Landform 1 with RDI shift suggestion

Analysis of FL 19232 Visual Quality

Dr. Ken Fairhurst, RPF, RDI Resource Design Inc, was asked by Interfor Corporation to review the Visual Plan prepared for the proposed FL A19232 cutblocks 129 and 227. RDI has 20 years of progressive experience in all aspects of Visual Resource Management and Planning in all regions of British Columbia, and is highly-regarded as an independent advocate for excellence in the professional discipline of VRM.

Visual Impact Assessment
Bear Lake – FL A19232

Interfor Visual Force Analysis - Photo VP 1 and Map

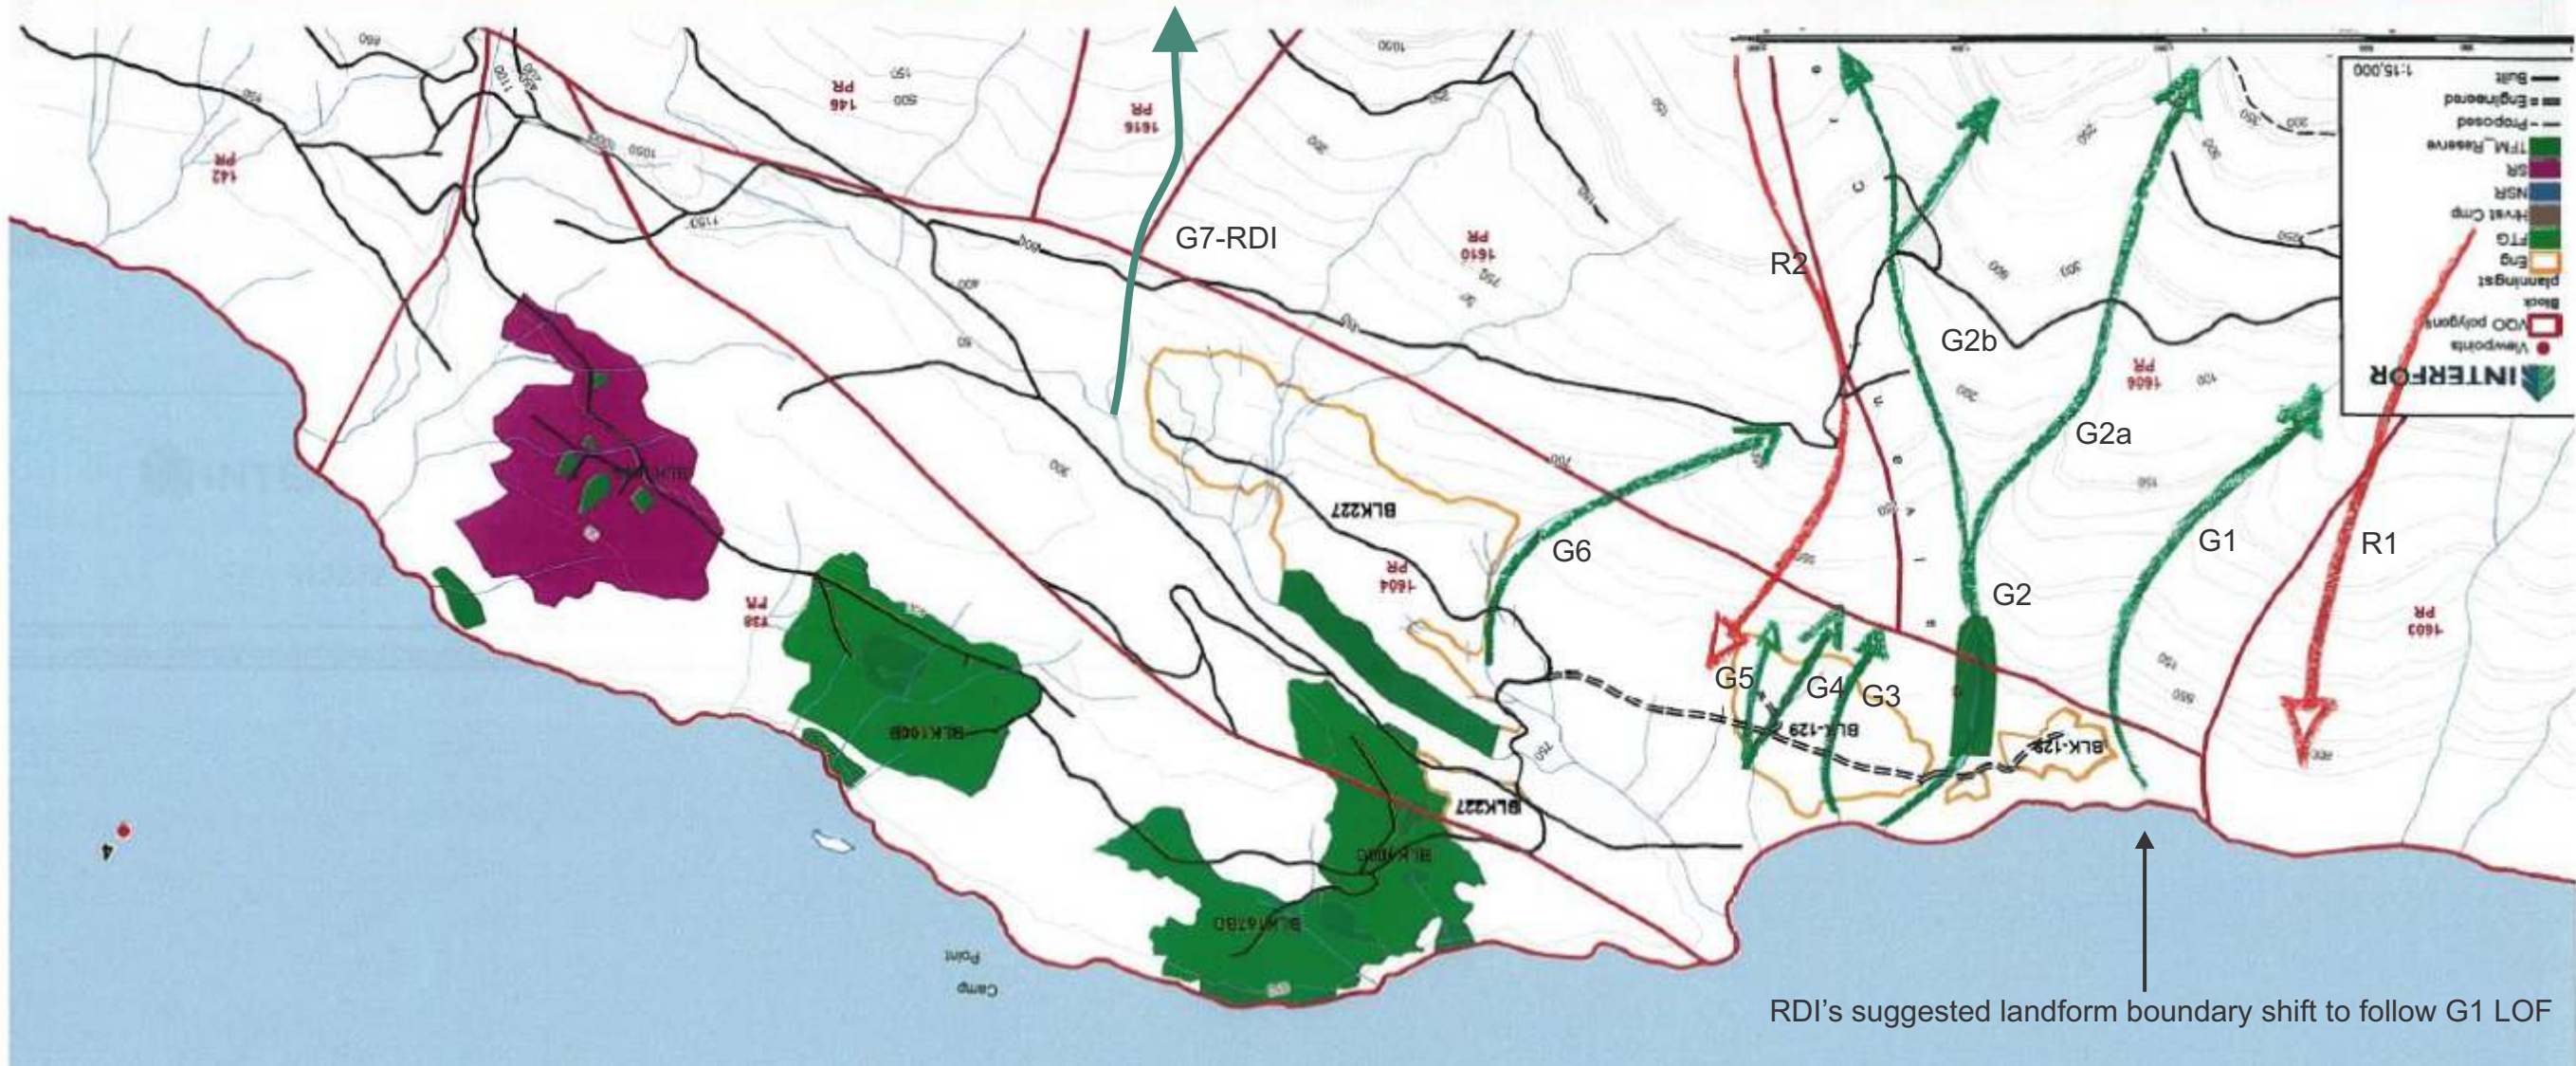
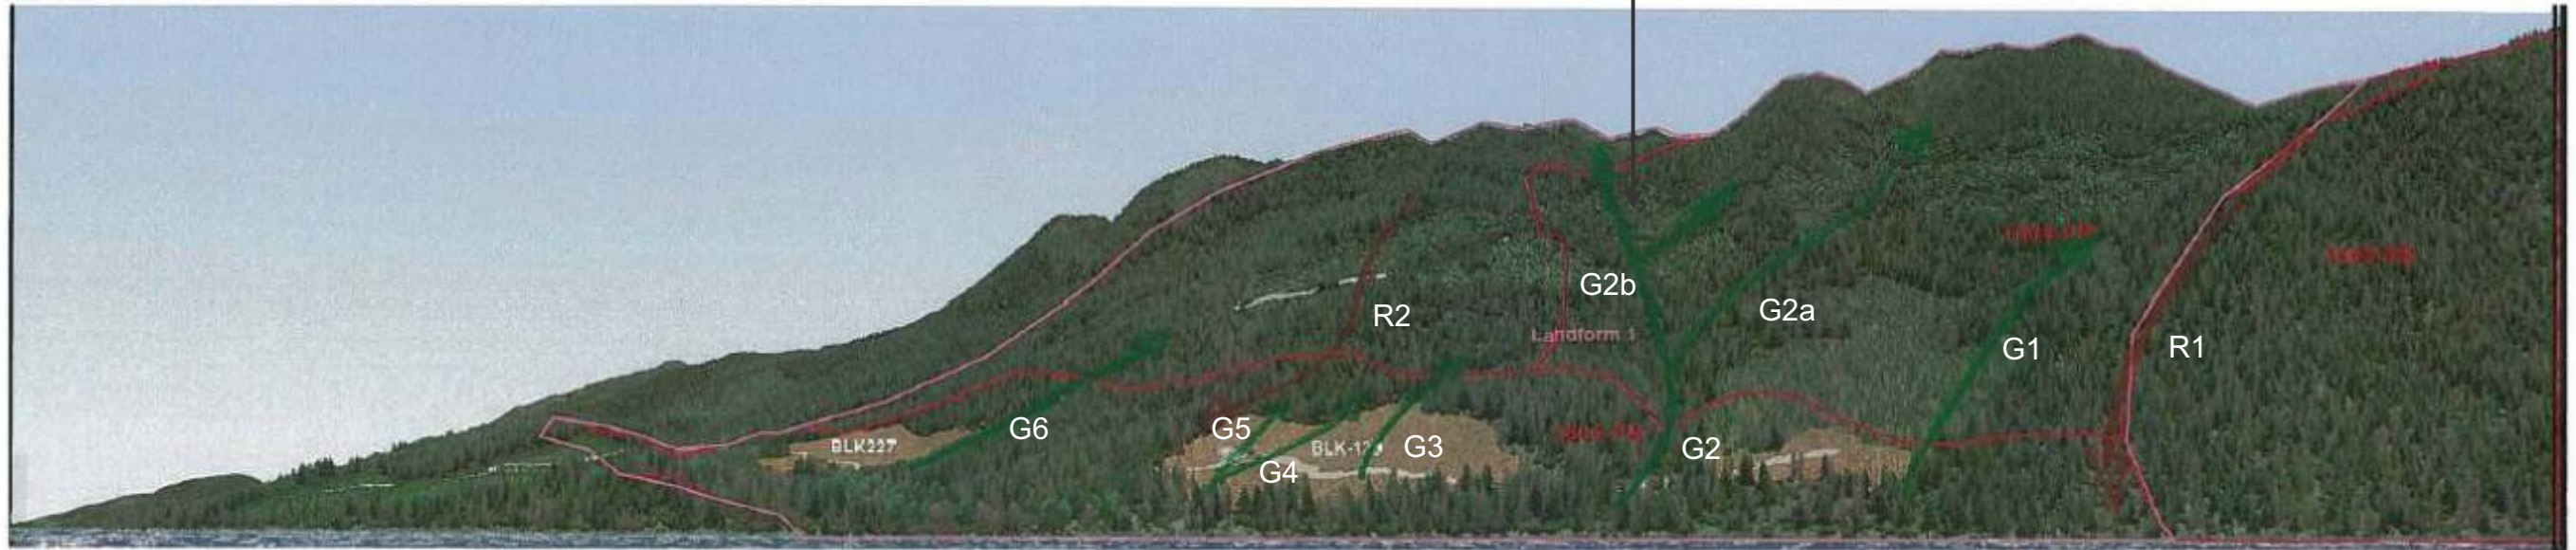
A distinct gully flows down the centre of the landform. It provides a strong visual force line to guide design and layout (numbered G2b by RDI on Interfor's visual force analysis page). The visual force analysis page (lines of force or LOF) for Viewpoint 1 indicated Interfor's understanding and good use of force lines - red arrows down convexities (ridges); green arrows up concavities (draws and gullies).

Cutblocks and the very substantial leave areas between the openings were designed to respond to them (see Cutblock Design Section of this report). RDI assigned numbers to the LOFs to assist interpretation between the perspective and planimetric views of the force lines. By so doing, the boundaries of Landform 1 became more obvious. RDI concluded that Landform 1 (the design landform for the cutblocks) properly incorporates the visible portion of VSU 1604 at the base of the main slope plus the 2 VSUs of Hkusam Mountain directly above the cutblocks – VSUs 1606 and 1610.

Interfor Photo VP 1 with Superimposed Cutblocks and Interfor Landform 1 with RDI suggested adjustment

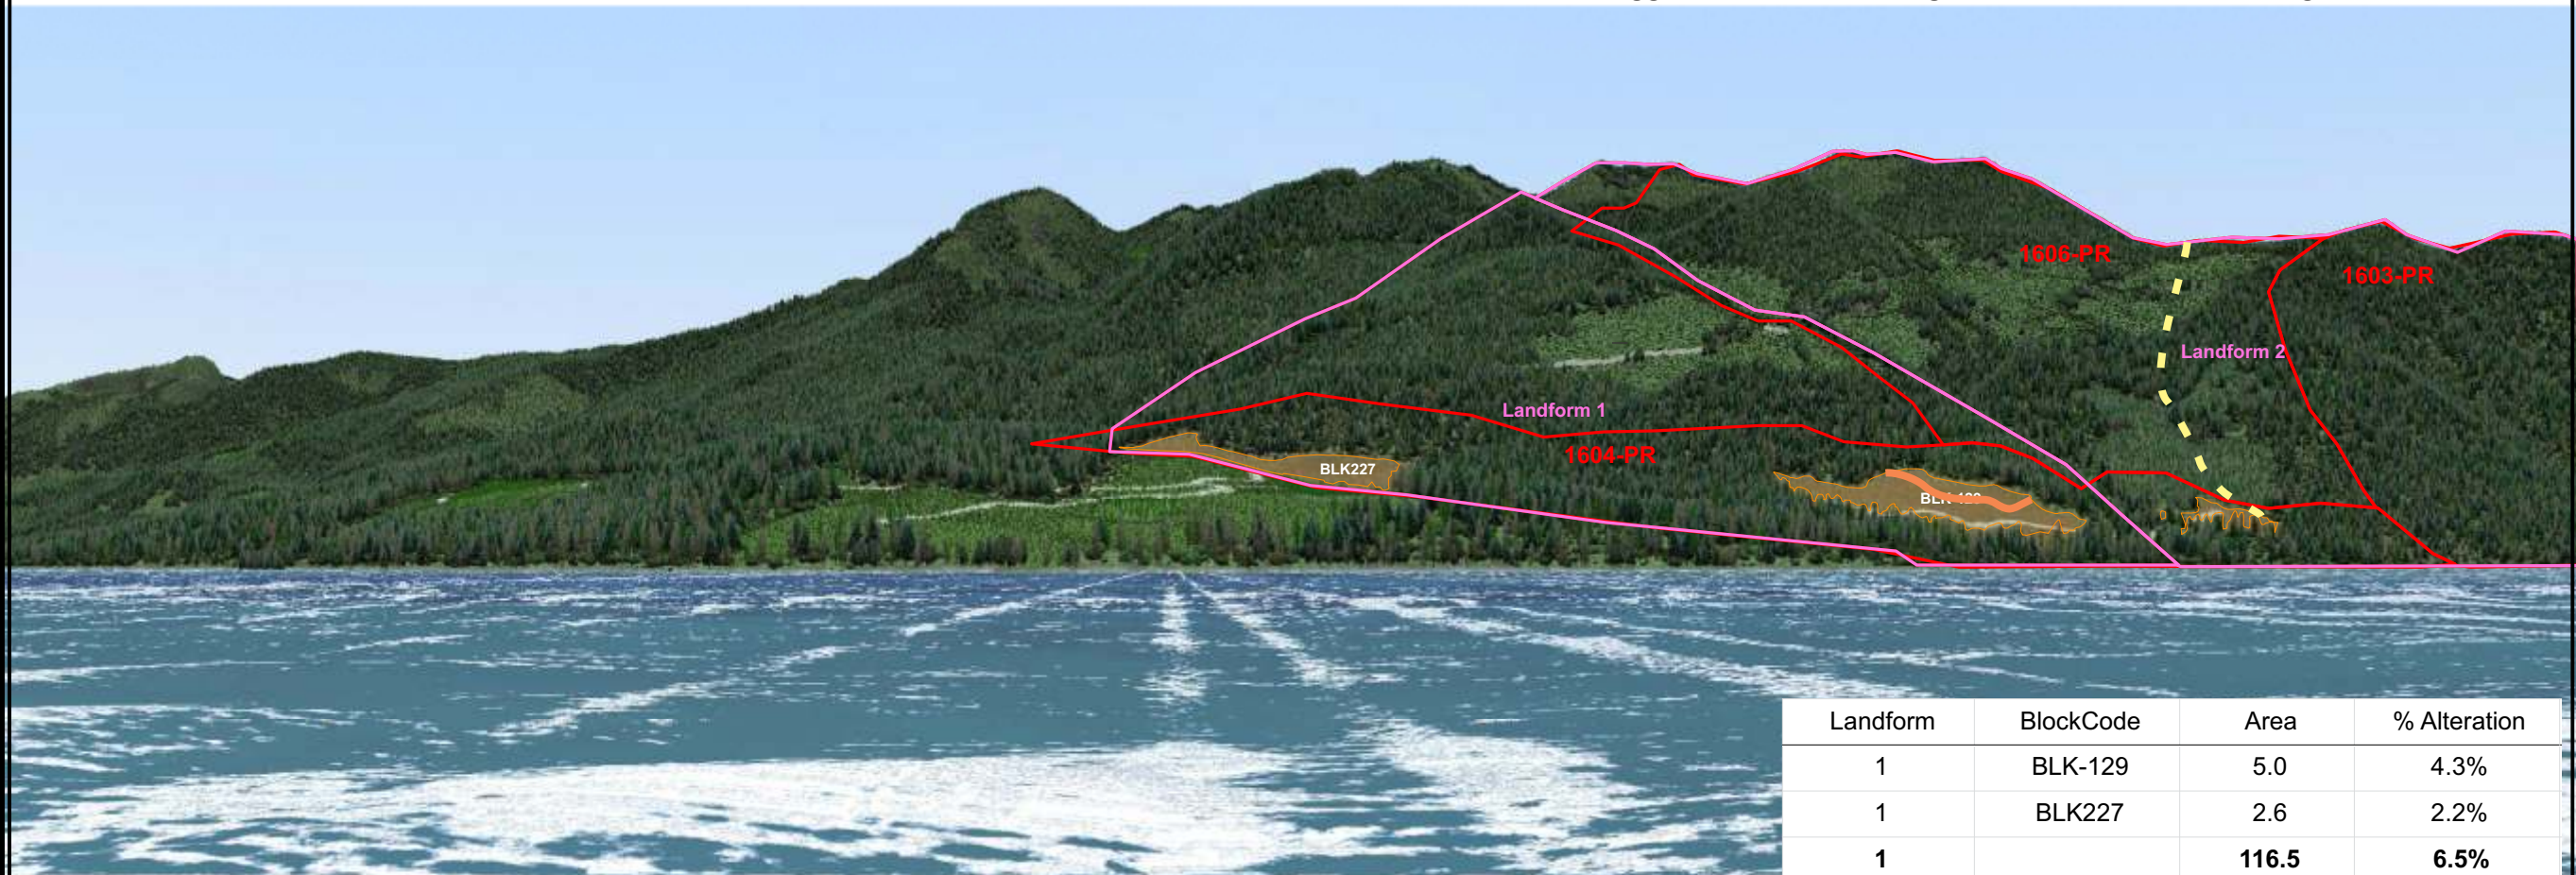
While RDI concurs with the Landform 1 assembly, it would prefer to see it utilize the immediately adjacent gullies (G1 and the LOF added by RDI: G7) rather than the vertical ridges as defining the east boundary (G1 LOF) and west boundary (just beyond the VSU 1610 edge – G7). The reason is that landforms complete themselves by rounding into the concavities rather than stopping at ridges. The dashed-line suggestions made by RDI in purple on the key map and in solid yellow on the iMAP BC map of complete VSUs shows the suggested adjustment. For clarity of understanding and verification, Interfor's cover map should reveal the VSUs and landforms to the height of land as shown in RDI's iMap.

RDI's recommendation is to bring the upper southwest corner somewhat downhill as suggested by the orange line in the Viewpoint 1 simulation. Without the benefit of having the use of the 3D model for exact location, RDI remains unsure of the planimetric location of the suggested adjustment. By interactively tracing in perspective view with VNS to see the corresponding location in planimetric view, Interfor can produce a quick and simple approximation of line can be determined in VNS, which can then be exported to bring into ArcMap to refine the shape of the opening.

Interfor Current Plan from Viewpoint 2 with RDI suggested adjustments to BLK 129 and Landform 1

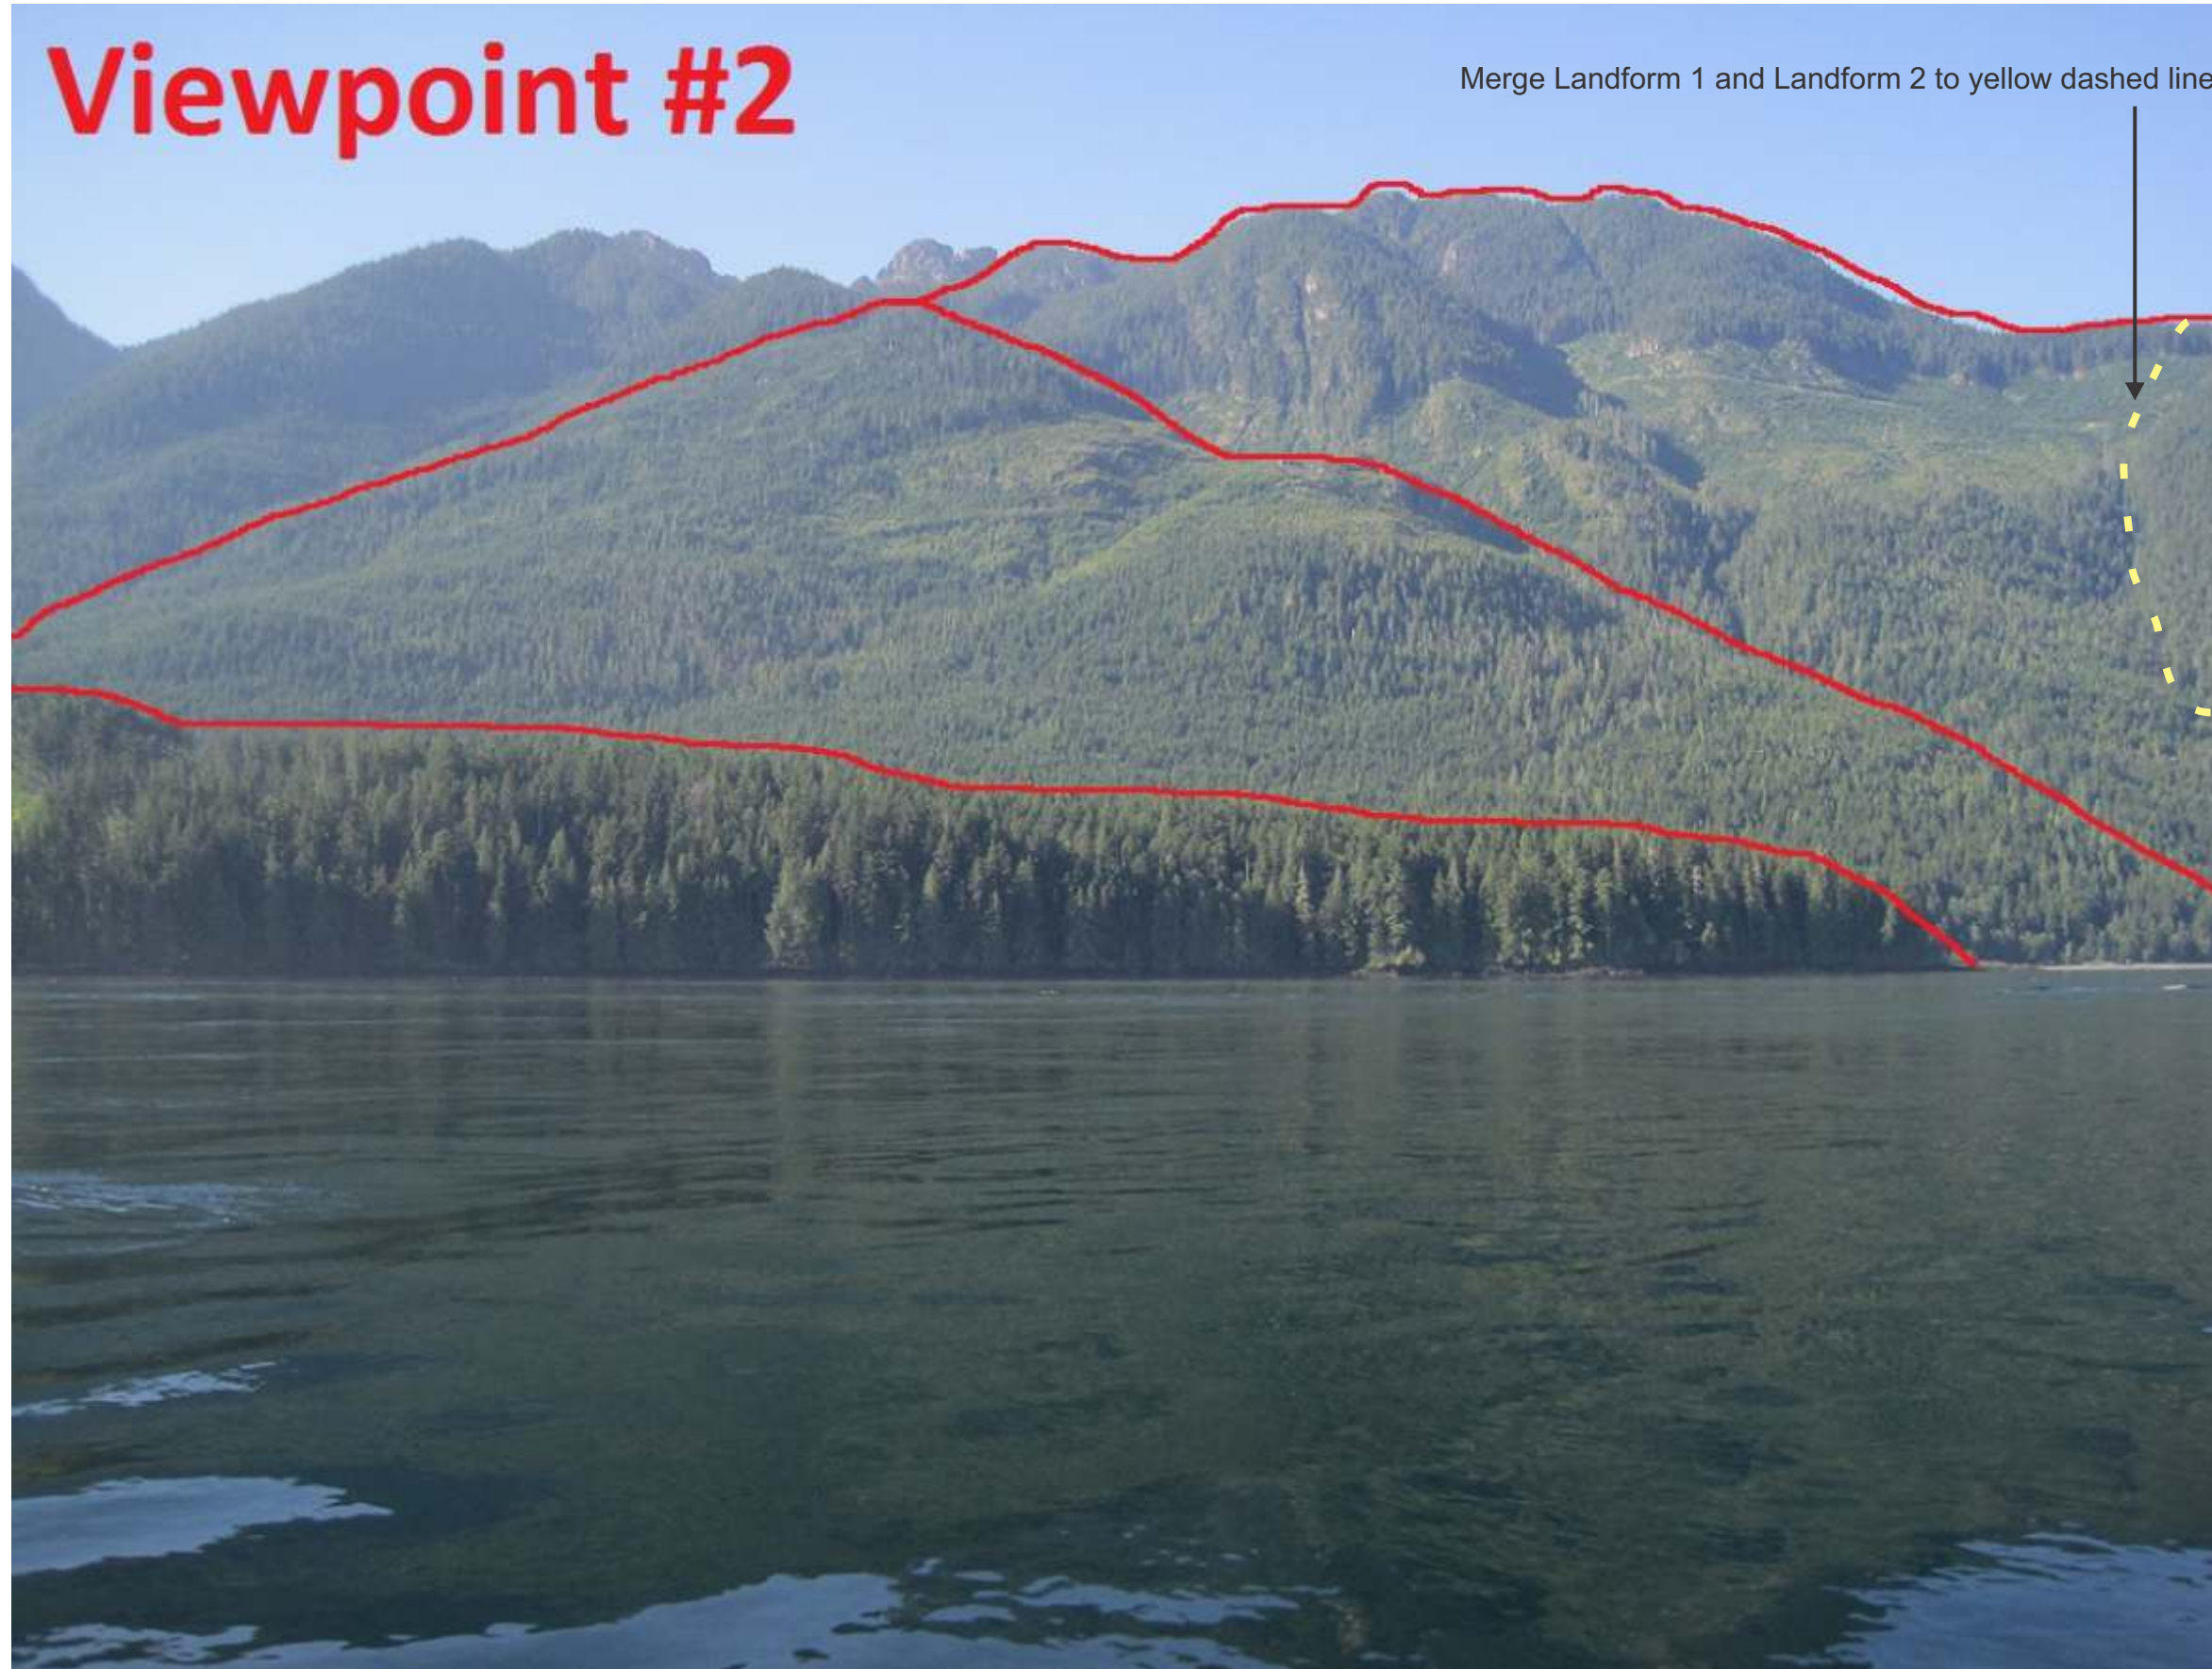
Interfor has defined 2 landforms seen from Viewpoint 2. Whereas all cutblocks fitted within the single landform from Viewpoint 1, a division was made in that landform down the ridgeline boundary between VSUs 1610 and 1606, placing the small westerly blocks into Landform 2. Landform 1 extends east to the west ridgeline of VSU1610 as in the Viewpoint 1 landform. The west extent of Landform 2 was not outlined on the simulation, though RDI inferred that it extends fully across VSU 1603 rather than to the break between VSU 1603 and 1606 as in Landform 1. RDI would prefer to leave VSU 1603 out of the design landform. It leads northwesterly towards Sayward as a distinctly lower topographic unit having a much simpler character than the main Hkusam landform.

Again, RDI prefers landform divisions down concavities (green LOFs) and would encourage the west boundary to be shifted to LOF G1 as numbered on the LOF page. The purpose of the split into two landforms from Viewpoint 2 was not addressed by Interfor in their report. The larger single design landform as indicated in Viewpoint 1, together with RDI's suggestion to utilize the gullies (G1 and G7) immediately adjacent to the current ridges defining the landform should be considered for the Viewpoint 2 simulation. The RDI suggestion would easily accommodate the proposed alteration within PR limits while respecting the concept of landform definition. The coalesced, highly complex Hkusam landform provides greater opportunity to work with the strong vertical LOFs within the landform, which include the Viewpoint 1 LOFs. No LOF analysis was prepared by Interfor from Viewpoint 2. Placement of landform boundaries on the key map by Interfor and LOF determination would assist that understanding.

RDI suggestion to merge Landform 1 and Landform 2 to yellow dashed line
 RDI suggestion to reduce height of BLK 129 to solid orange line
